Agenda Item #1Application 2023-56-CA

34 S. Reed Avenue

Update to After-the-Fact Approval: Install aluminumclad replacement windows that do not match muntin profile of the original windows, as issued COA required; replace two windows with French doors on façade; replace two-light window with single-light sash; remove attic gable window.

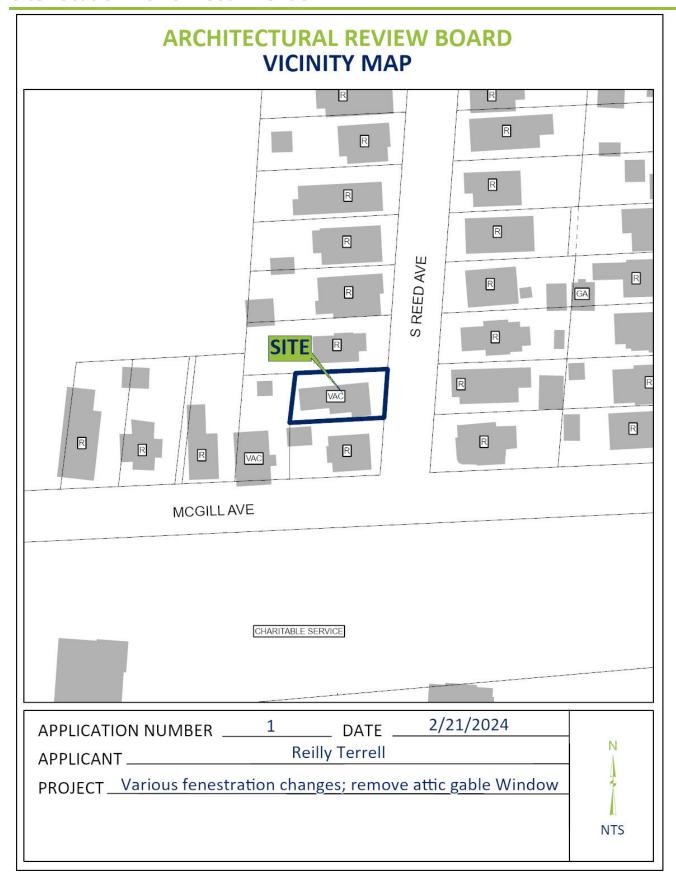
- Options for some indication of a transom (or genuine transom) in regard to the large, single-light window on the first floor of the façade
- Options for replacing one of the French doors on the second floor of the façade with a window matching the existing windows, in an evenly spaced arrangement across the façade.
- ARB members suggested that the missing trim at the installed windows be addressed and that Mr. Terrell should verify with his window manufacturer that the installation was done to the manufacturer's specifications.
- Mr. Terrell proposed square replacement porch supports. The ARB members present stated that the design would require a vote of the entire Board.

- Mr. Terrell stated that the window manufacturer is not able to make a simulated divided light thick enough to resemble the missing transom on the first-floor façade window. Possible alternative solutions presented were installing a two-over-two window to match other existing windows, or to install a simulated two-over-two divided light on the single-light window.
 ARB members were not amenable to installing a simulated divided light, but agreed with the option of replacing the single-light window with a two-over-two window to match existing windows. They recommended moving an existing two-over-two window from a secondary elevation to the façade and reusing the single-light window on a non-primary elevation.

- Mr. Terrell has ordered a window for the second floor of the façade which will replace one of the French doors. The second floor fenestration pattern (from left to right) will be converted to single door; two-over-two window; two-over-two window.
